# GMX001 Lock Module Detent in RUN

## *First Design Concept*

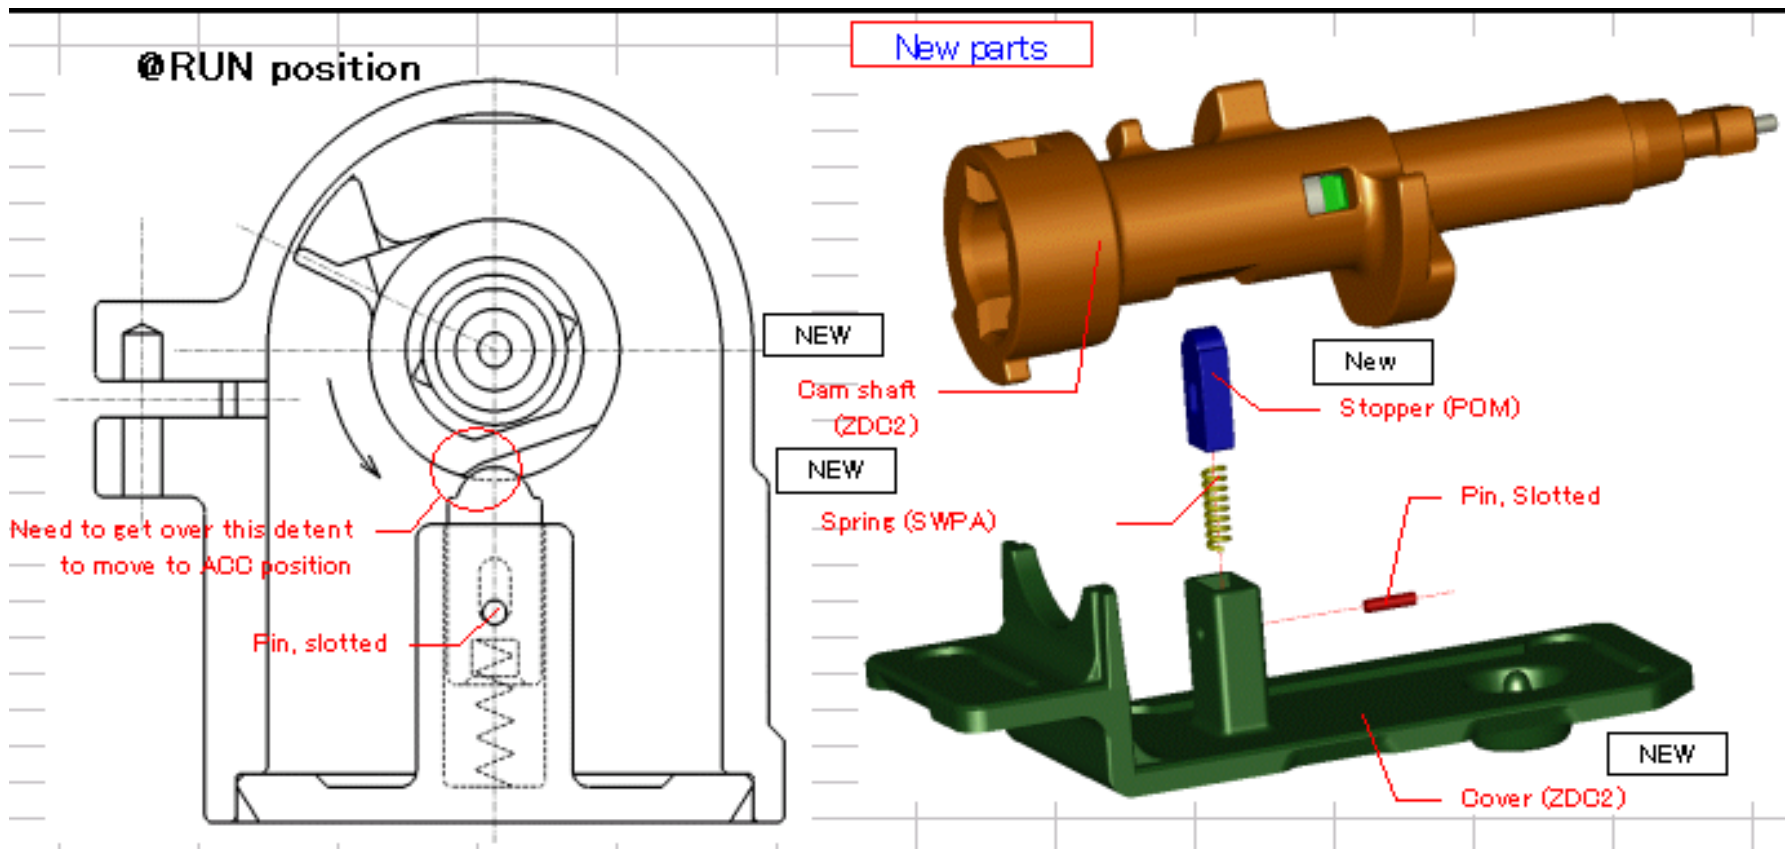
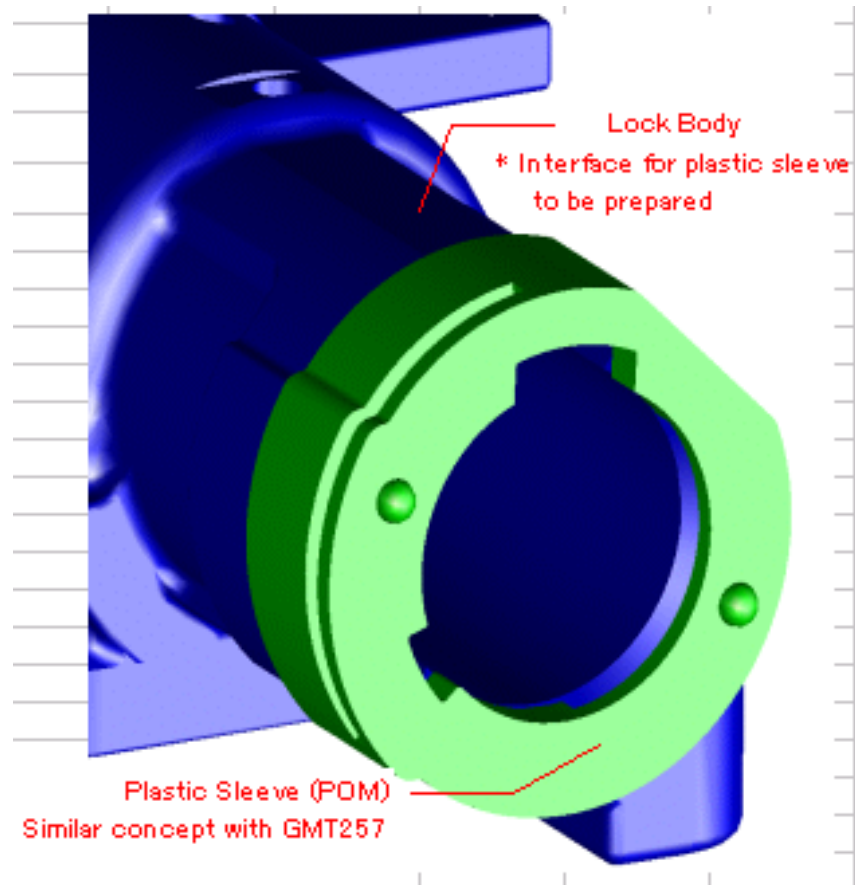
- Detent between lock cover and cam shaft:

- Design Evaluation (Engineering and Cost)
  - The most preferred by supplier

<b><i>Engineering</i></b>		<b><i>Cost &amp; Timing</i></b>		
<b>Benefits</b>	<b>Concerns</b>	<b>Piece Cost Increase</b>	<b>Tooling</b>	<b>Lead Time</b>
No interface tuning required (between lock housing and cylinder)	-A few new components are needed - Torque specification needed by supplier	\$0.5716	179143 (new tooling)	About 1 year

## *Second Design Concept*

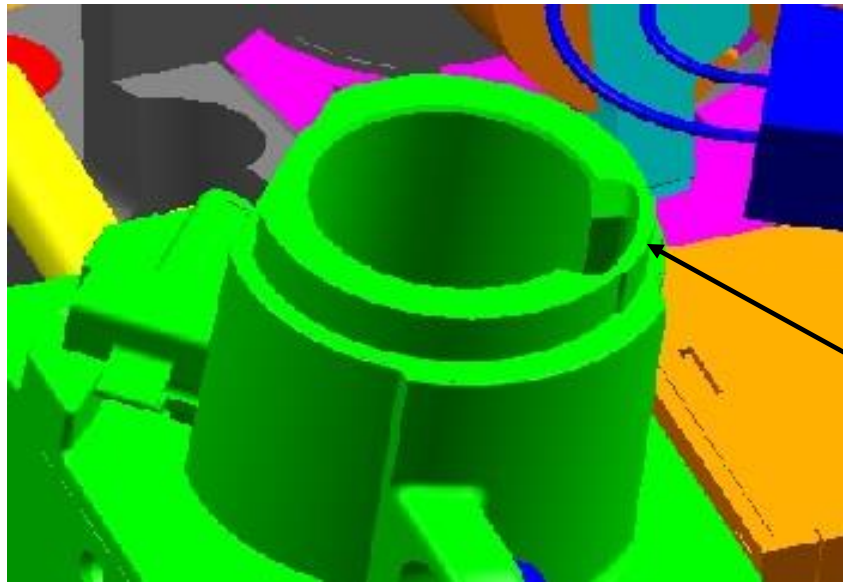
- Main concern with trimming of the lock housing to accommodate plastic sleeve

Material thickness  
creates concern for  
GMX001 lock hosing

## ➤ Design Evaluation (Engineering and Cost)

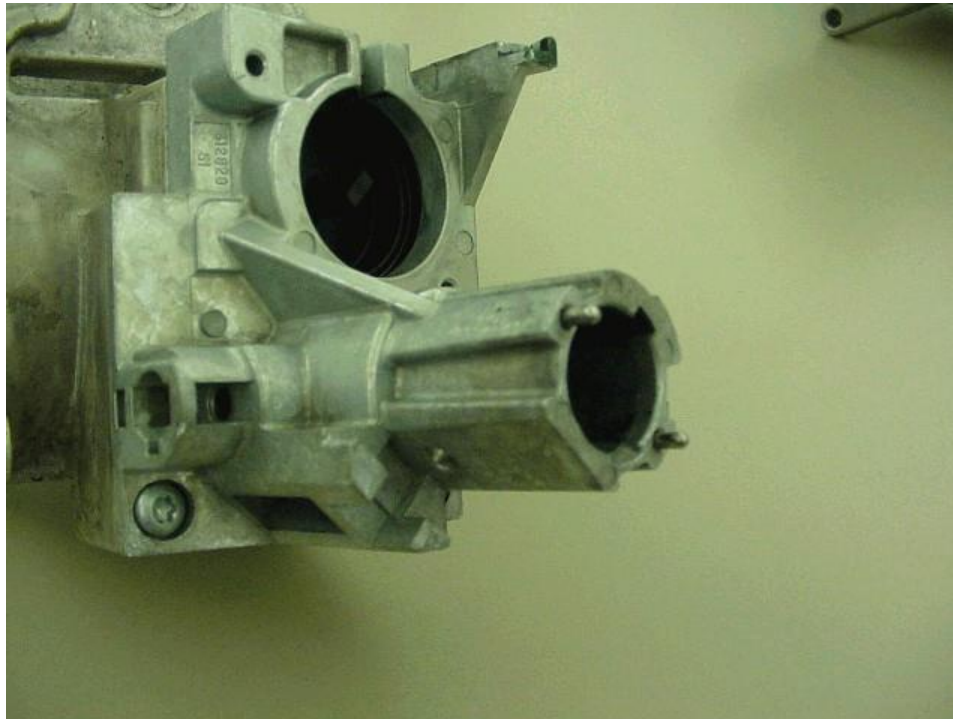
<b>Engineering</b>		<b>Cost &amp; Timing</b>		
<b>Benefits</b>	<b>Concerns</b>	<b>Piece Cost Increase</b>	<b>Tooling</b>	<b>Lead Time</b>
Design concept already proven to work for GMT257	<ul style="list-style-type: none"><li>- Not enough material to trim from the lock housing in order to accommodate sleeve.</li><li>- Simultaneous tuning effort from lock cylinder engineering and lock housing supplier</li><li>- No specification available</li></ul>	\$0.2758	\$152,145 (new tooling)	About 1 year

- Adding spring loaded pins to the lock housing:

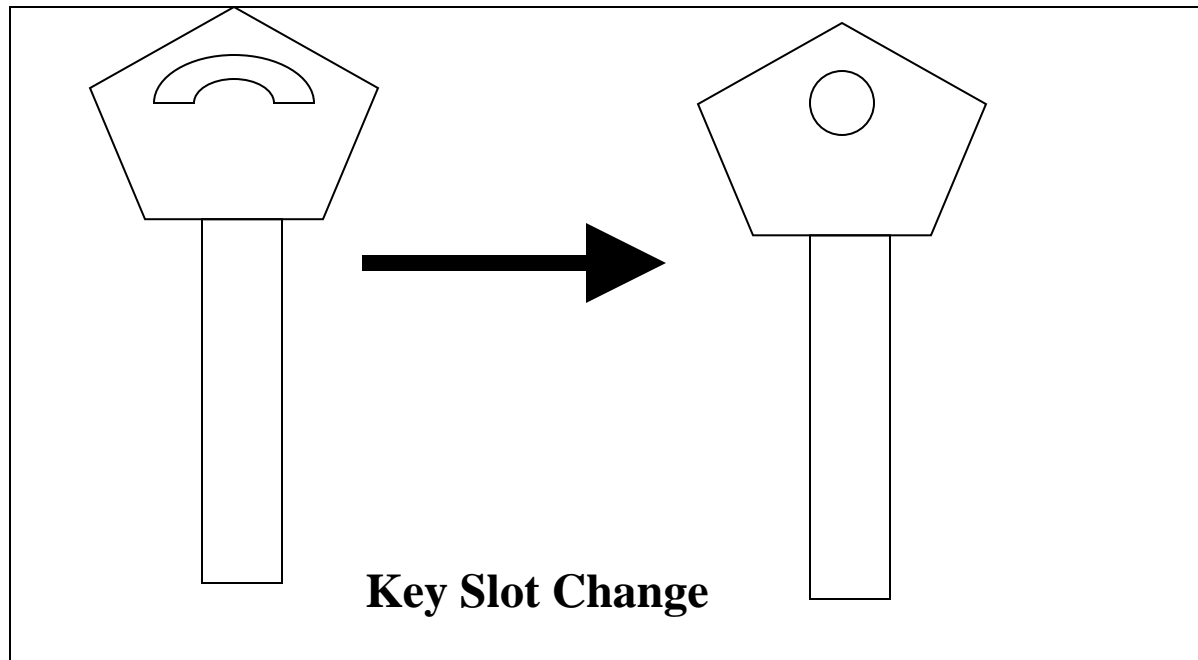
- Main concern with complexity in warranty.
- Ruled out by lock housing supplier
